Planning Representations and Objections to SODC regarding P24/S2642/FUL & P24/S2652/S73 & P24/S2651/DIS

Appendix 1 – JBA Technical Note September 2024

JBA Consulting (JBA) were commissioned by Thames Farm Action Group (TFAG) and Shiplake Parish Council to undertake a review of the drainage and ground stabilisation proposals for Thames Farm, Shiplake, RG9 3PH, submitted to South Oxfordshire District Council in August 2024 as part of three planning applications:

Figure 3-1: Comparison of 2D model boundary with topographic catchment boundary

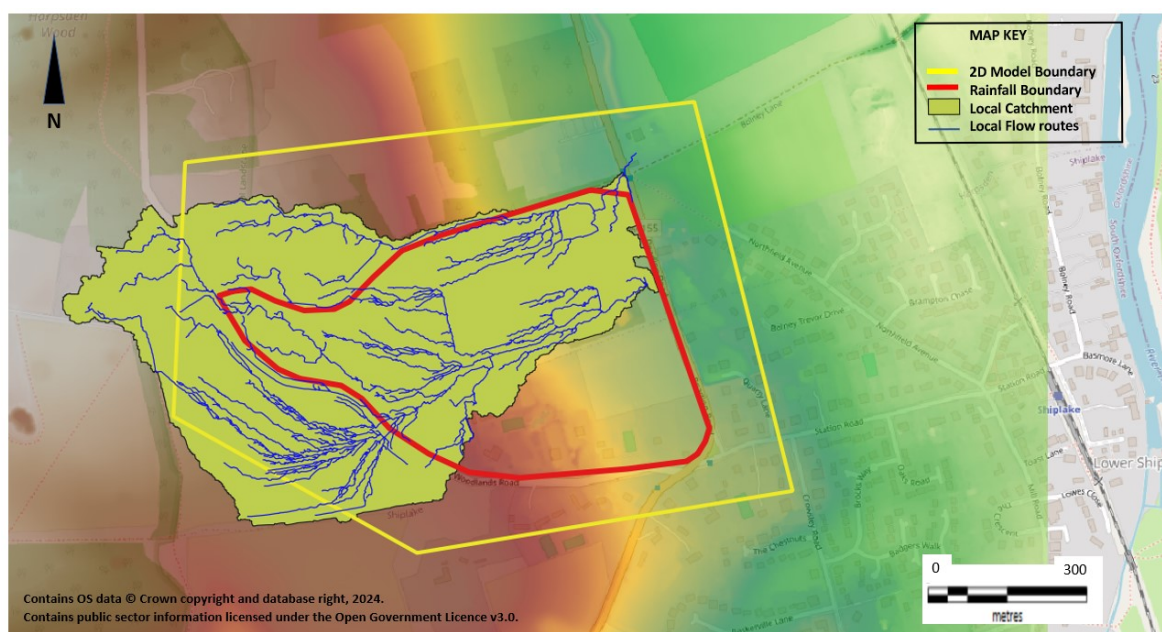
The applicant has used a TUFLOW 2D model to assess surface water inflows in the form of hydrographs) onto the site from third-party land upstream. These hydrographs are then utilised from the Causeway Flow drainage model. It is evident in the figure below that the boundaries of the 2D surface water model (TUFLOW - yellow boundary) and the local catchment (as delineated after a GIS catchment analysis of the local 'micro' catchments utilising JBA's own QGIS Watershed Delineation Tool) do not coincide, therefore, the amount of water entering the site offside is underestimated. This, in

turn, gives an underestimated hydrograph representing the offsite flows in the drainage model (Causeway Flow).

It must also be noted that in the report the rainfall boundary (red boundary), erroneously, is depicted as even smaller than the 2D surface water model, representative of the actual catchment (see figure below), although this does not actually appear to have been the case in the model.

Figure 3-3: August 2024 drainage layout plan 4 © Taylor Wimpey

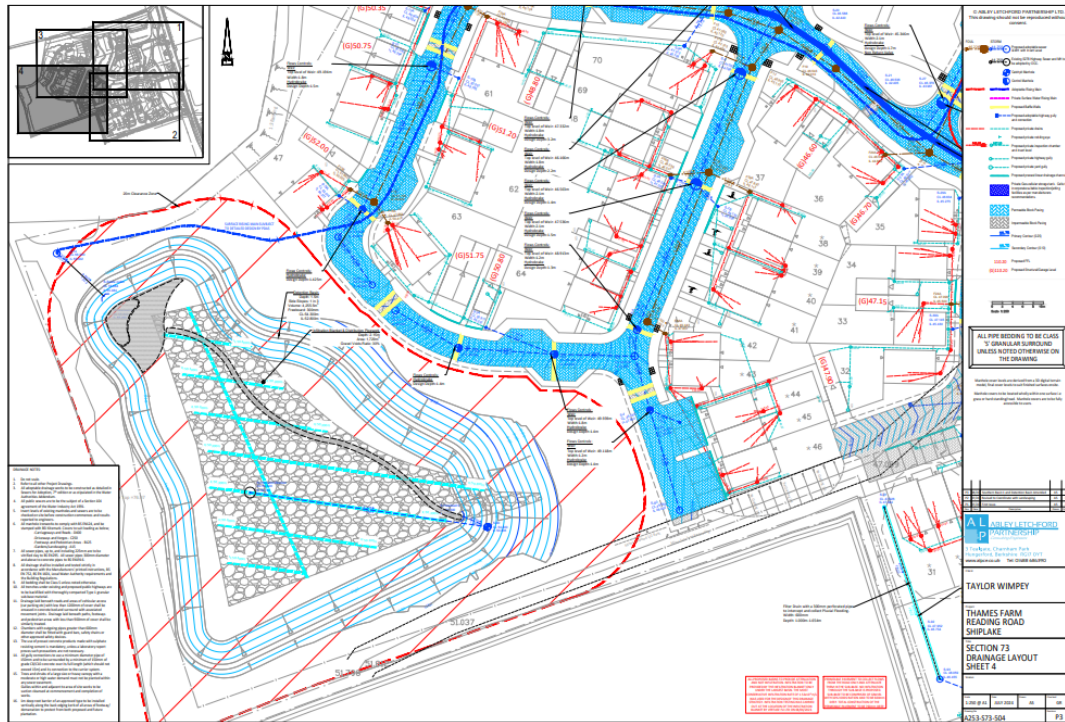
The deep-seated void in the western part of the site coincides with the proposed location for the infiltration basin (Figure 3-3). However, the 2024 drilling and grouting plan (Figure 3-4) shows only minimal works in this area. It is not clear whether this is as a result of a reassessment of the voids in the part of the site.

Considering the above it is evident that the 2024 proposed drainage system's sole disposal feature (infiltration basin) is sitting above a deep-seated void. Therefore, explanation is required as to the reason for limited grouting works in this area. When storing up to 2.3m of water, there would be significant ground loading and potentially rapid scour of existing voids if these are not stabilised prior to construction of the basin. If they are treated, as discussed above the infiltration rate needs to be adjusted, and preferably reconfirmed after the grouting works, to ensure that it is adequate to safely discharge the site's surface water to the ground.

Figure 1 : Stonor Park groundwater levels

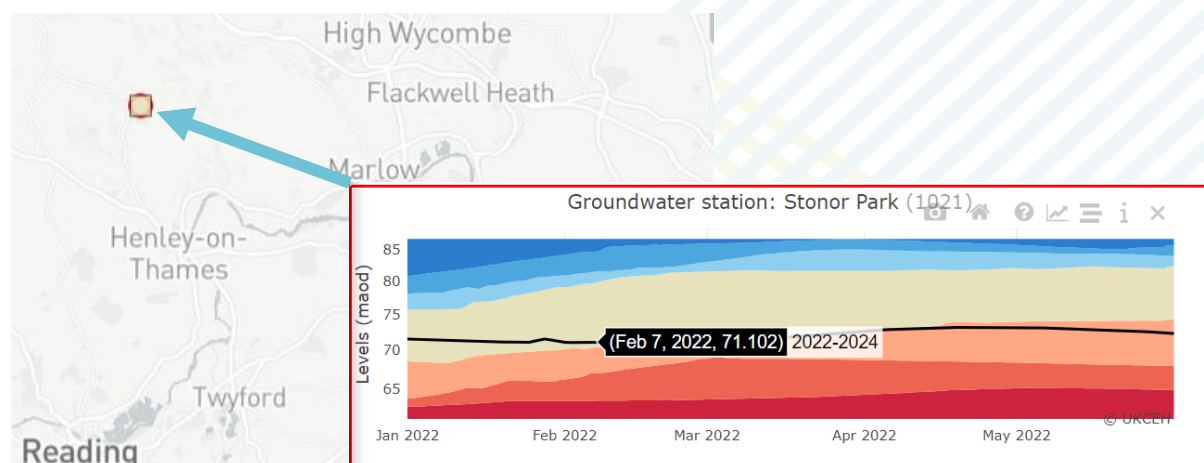
A network of monitoring boreholes has been installed over several rounds of ground investigation works and is considered sufficient to establish groundwater level over the proposed development. Piezometric levels have been monitored over winter 2022/2023 which have been used to establish groundwater levels although the HIA mainly relies on February 2022 to derive groundwater levels. February 2022 groundwater levels records from Stonor Park borehole; in the Chalk, c.10km North of the proposed development and presented in Figure 1 below; indicates general groundwater level was low at the time. The HIA fails in general to consider higher groundwater levels or varying groundwater levels effects on the risks identified.
